ECE/TRANS/WP.29/2007/84
19 July 2007

World Forum for Harmonization of Vehicle Regulations

Proposal for Supplement 1 to the 02 series of amendments to Regulation No. 107
(Buses and coaches)

Submitted by the Working Party on General Safety (GRSG)

"Figure 30

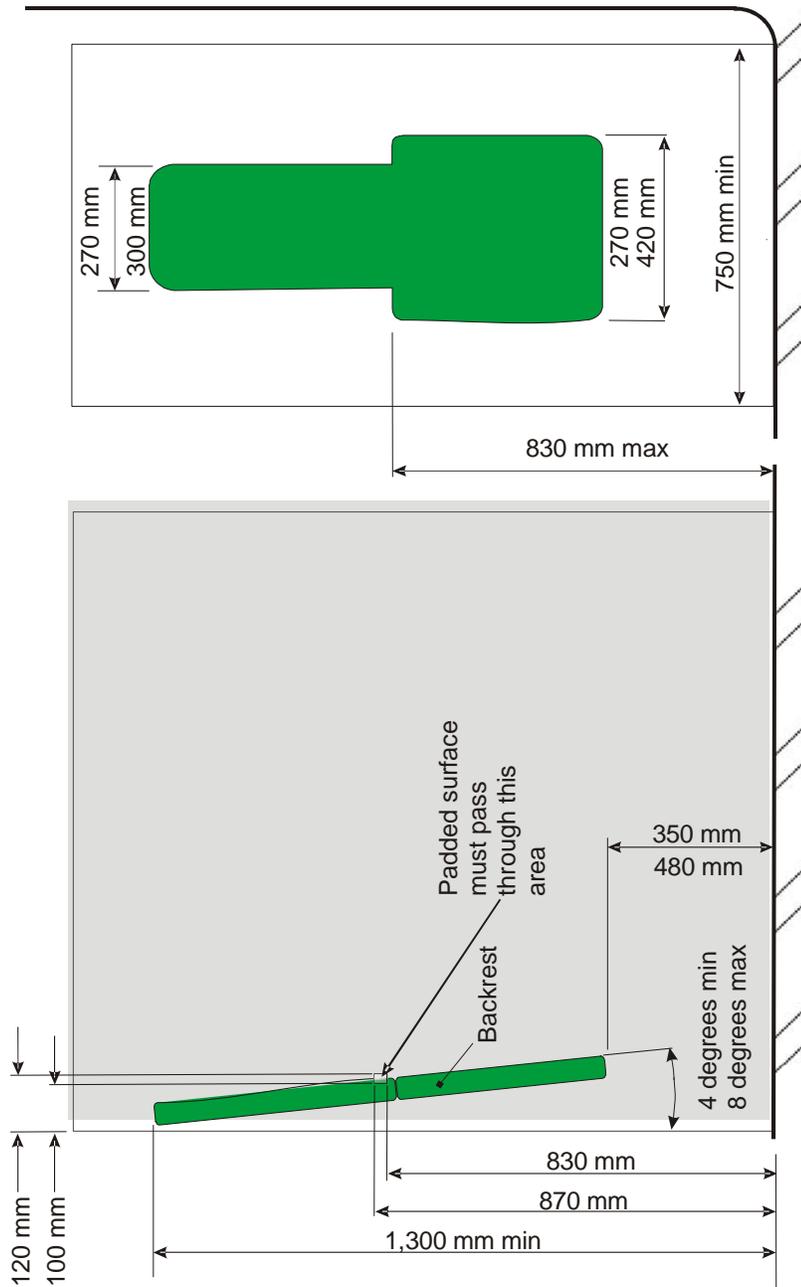
Insert a new Figure 30, to read:

EXAMPLE OF A BACKREST FOR A REARWARD-FACING WHEELCHAIR

(see Annex 8, paragraph 3.8.6.)

Figure 1

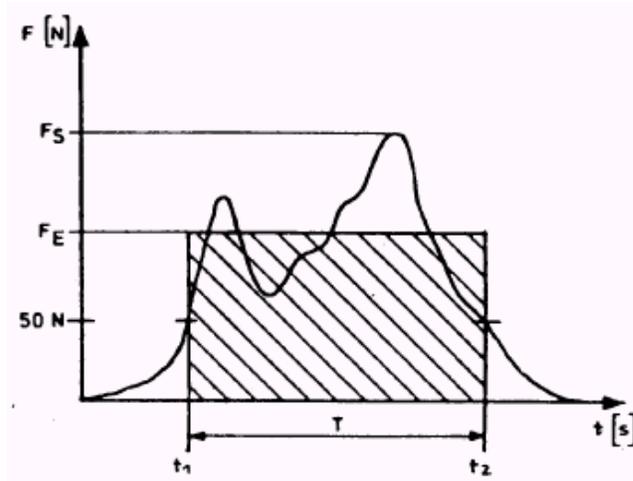
2.5. The relation between the above parameters is shown in figure 1 below (as an example):

Figure 2

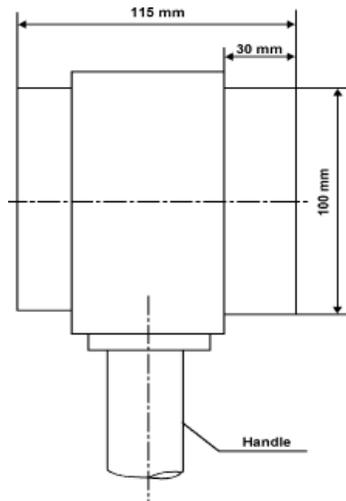
- 3.5. The deviation of the reading from the rated value shall not be more than ± 3 per cent.
- 4. Measuring device
 - 4.1. The measuring device shall consist of two parts: one handle and one measuring part which is a load cell (see figure 2).

- 4.2. The load cell shall have the following characteristics:
 - 4.2.1. It shall consist of two sliding housings with the outer dimension of 100 mm in diameter and 115 mm in width. Inside the load cell a compression spring shall be fitted between the two housings such that the load cell can be pressed together if an appropriate force is applied.

- 4.2.2. The stiffness of the load cell shall be 10 ± 0.2 N/mm. The maximum spring deflection shall be limited to 30 mm so that a maximum peak force of 300 N is achieved.
